Lahontan Regional Water Quality Control Board

SUBJECT: PROSECUTION TEAM RESPONSE TO COMMENTS AND PROPOSED REVISIONS TO AMENDED DESERT VIEW DAIRY CLEANUP AND ABATEMENT ORDER (CAO) R6V-2008-0034A4

**AMENDED CLEANUP AND ABATEMENT ORDER NO. R6V-2008-0034A4-(REVISED
PROPOSED)**

Attachment 1. Location Map and Revised Affected Area

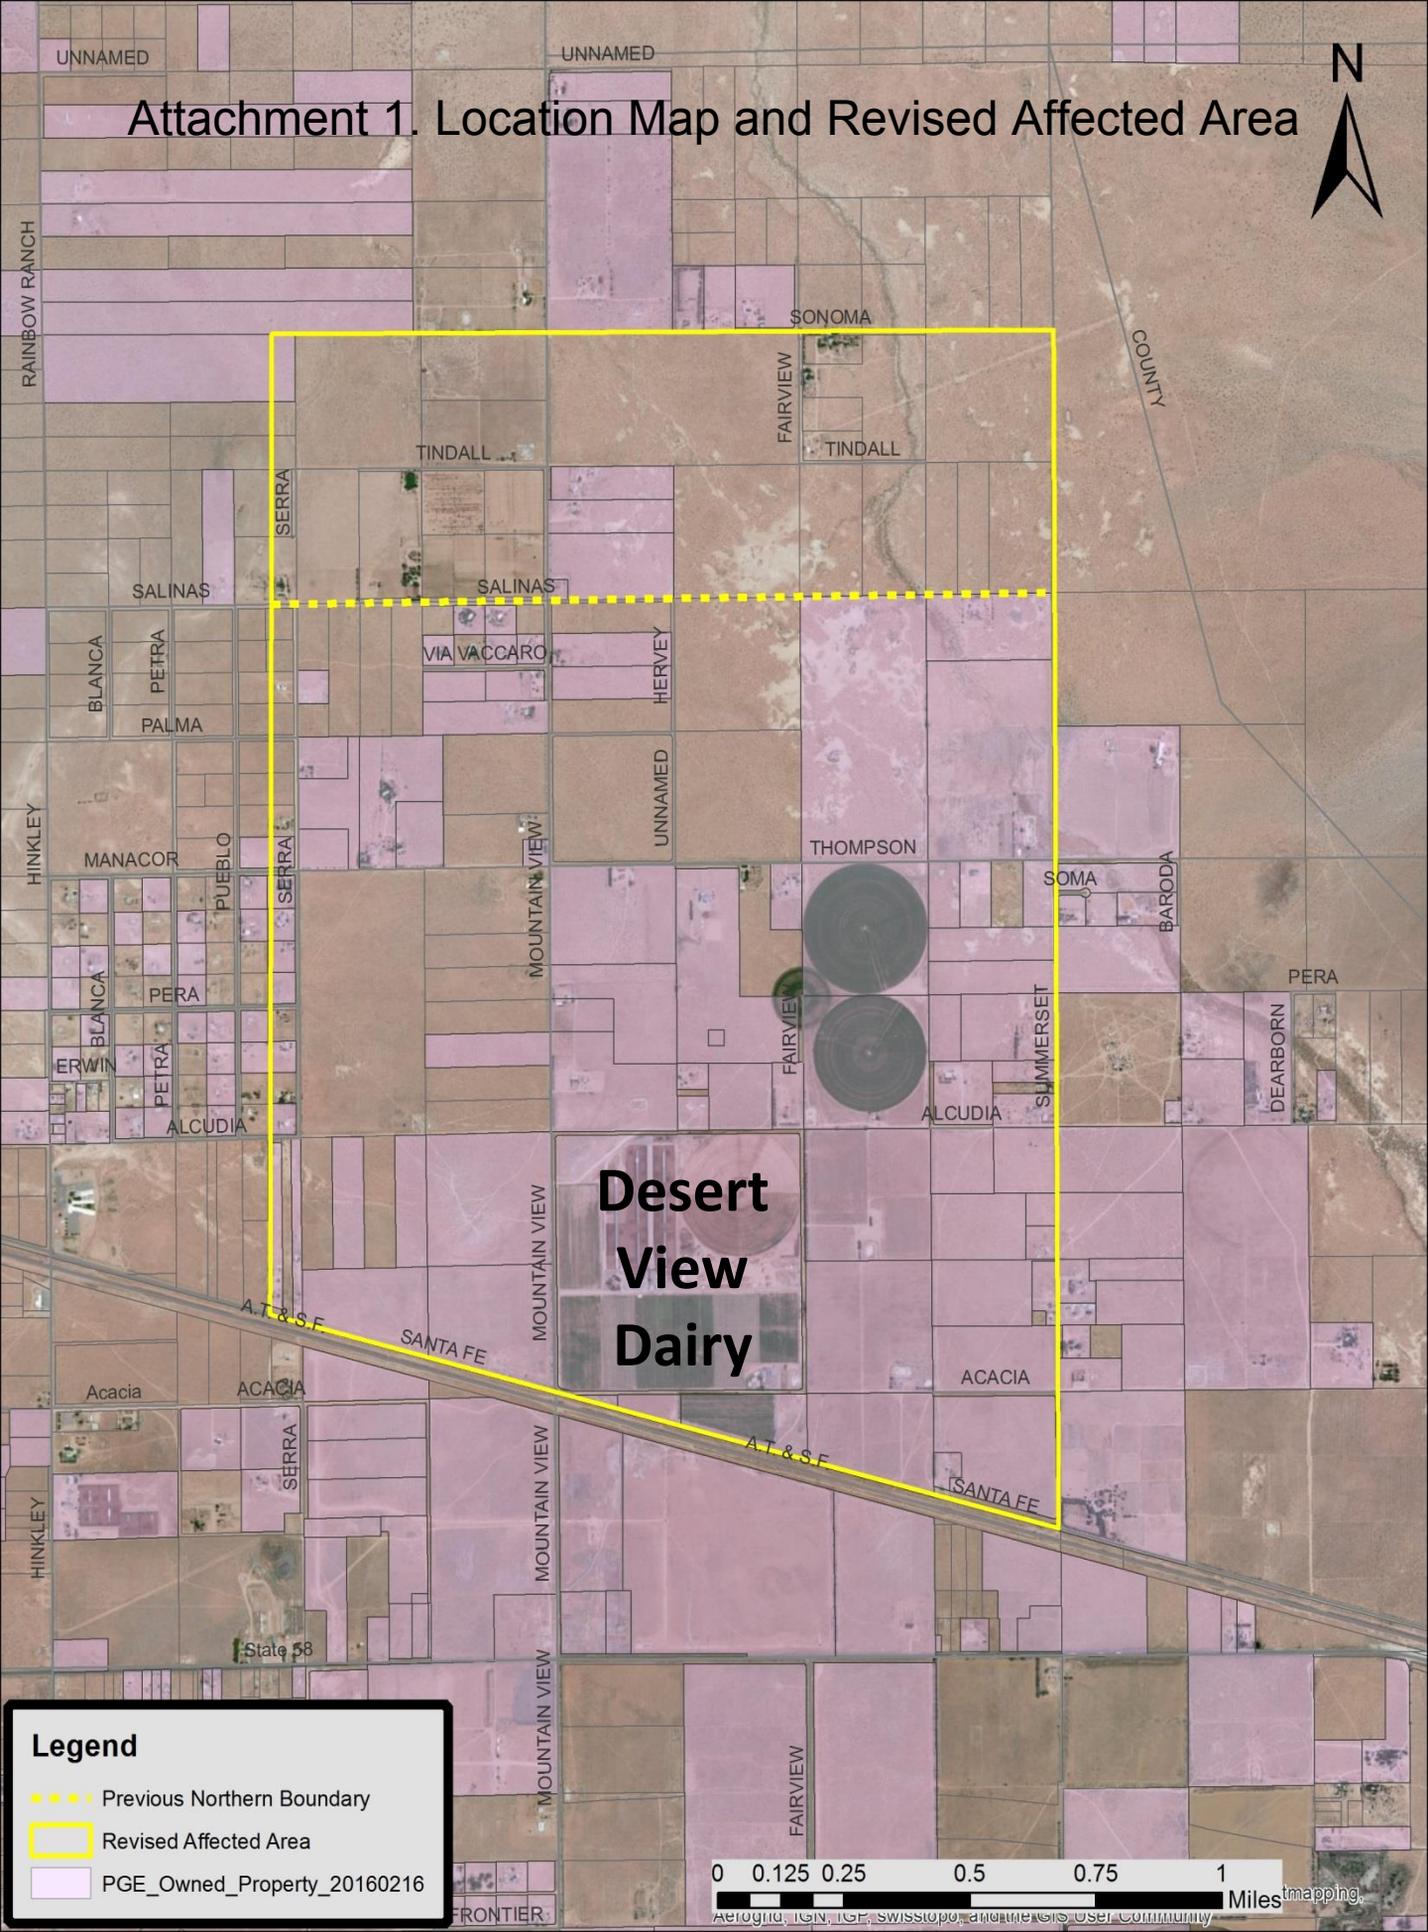
IRP-6. On Attachment 1, the location of the DVD is shown along Serra Road and it should be located on Mountain View Road on the enclosed map.

IRP-9. Suggest that a map is included showing parcel ownership to illustrate the number of possible replacement water recipients and properties owned by the dischargers.

Prosecution Team Response: The comment is correct. The map will be revised and replaced.

- Recommended revision to CAO: Replace existing attachment 1 with new attachment 1.

Prosecution Team Response: A revised Attachment 1 will be included in the final CAO, showing the suggested information.
